Staff Report

To: BOZAR
From: Jessie Earley, Senior Planner
Meeting Date: BOZAR, February 24, 2026
RE: 322 Maroon Avenue, Final Review

PROJECT TITLE: Robert Harper (322 Maroon Avenue)

02/09/2026 DRC and 02/17/2026 BOZAR Site Plan

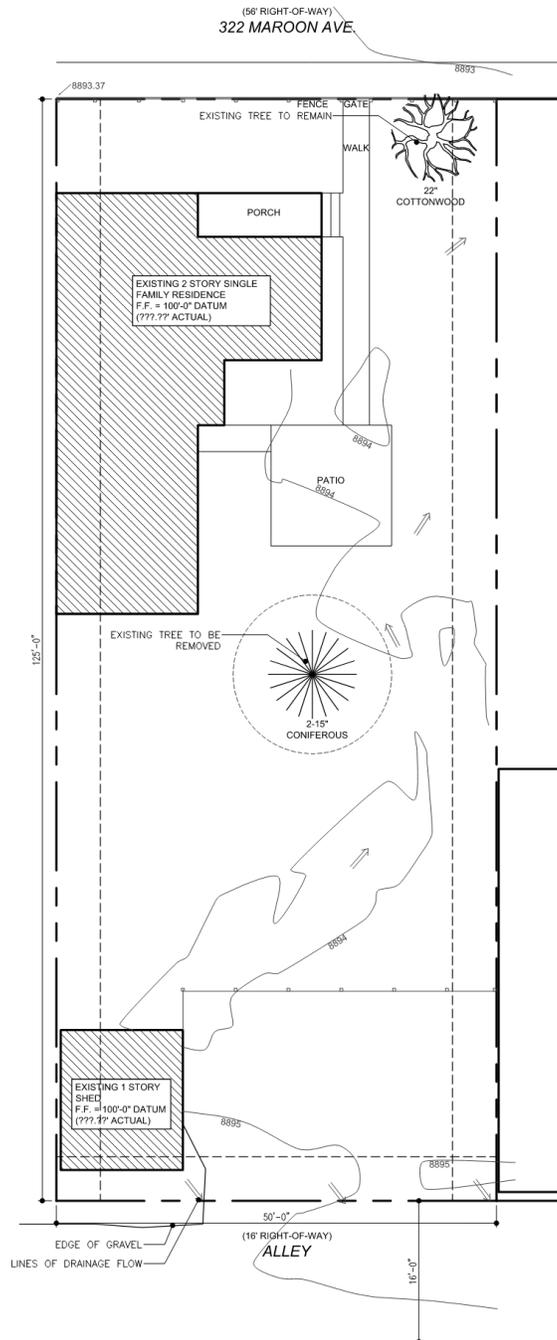
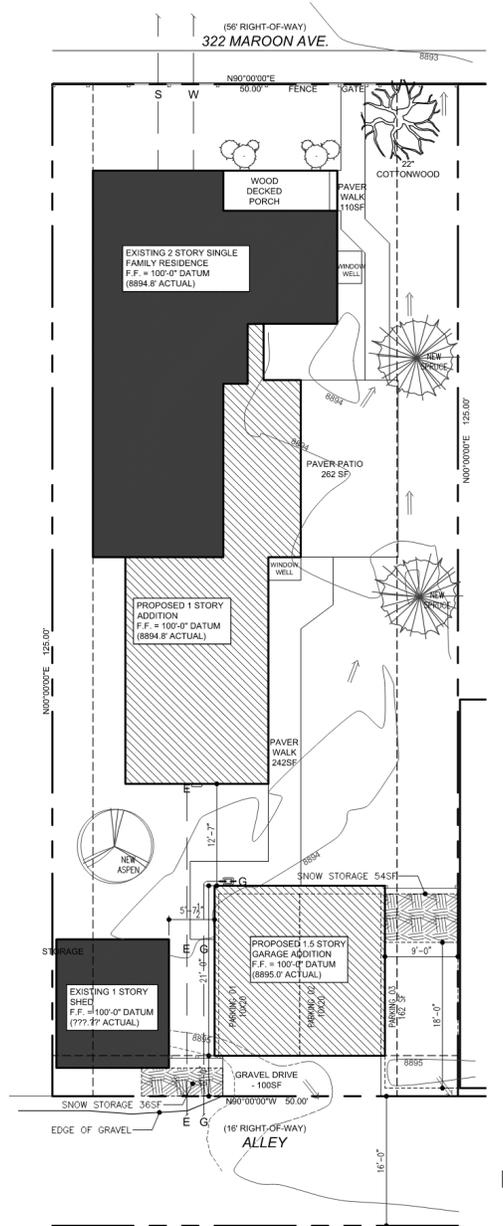
Landscape- sod and irrigation system to replace disturbed area- call out on site plan

11/18/2025 BOZAR proposal for east/demolition

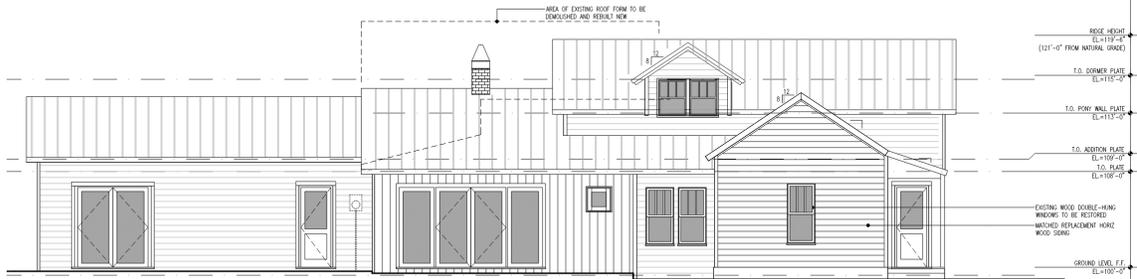
Look at proposed roof change on east elevation- Halley is not sure if getting rid of the hipped roof takes away from historic feel/shape of roof. She is not necessarily against it, but she thinks that the applicant should be aware that this might be ripe for BOZAR discussion

2/9/2025 DRC and 2/17/2026 BOZAR revised proposal for east/demolition

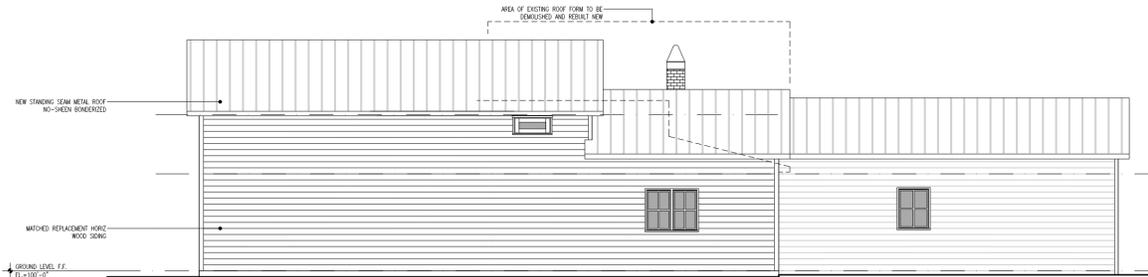
On the east elevation, Board members asked for the trim detail to be unified.

02/09/2026 DRC and 02/17/2026 BOZAR revised proposal for west/demolition

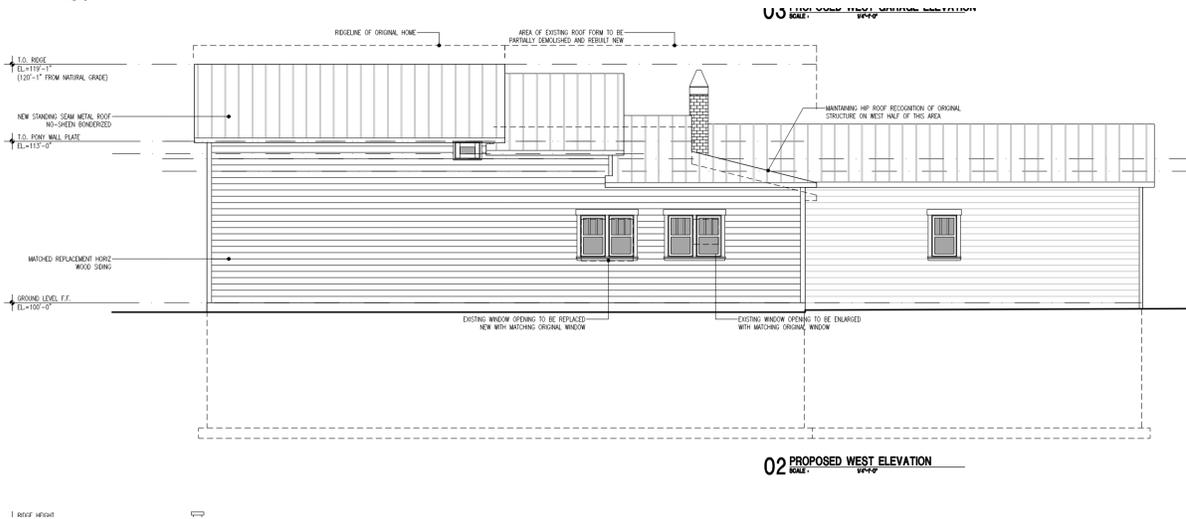
West elevation high, small window will be slightly larger but it fits the change all around, so that works

03 PROPOSED NORTH ADU ELEVATION
SCALE: 1/4"=1'-0"

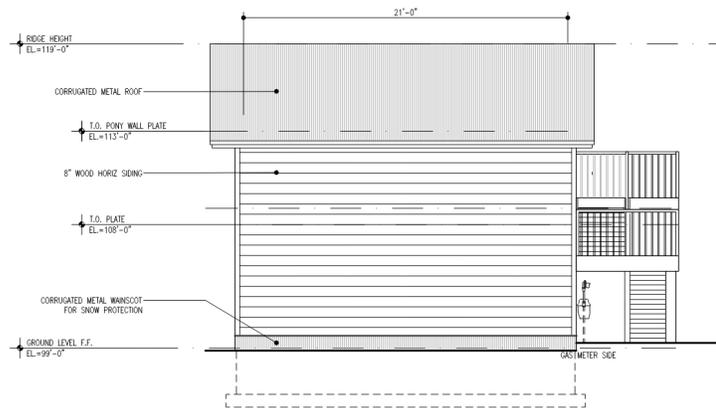
The metal materials were not supported for the deck and stair on the north side of the ADU. This will be revised.
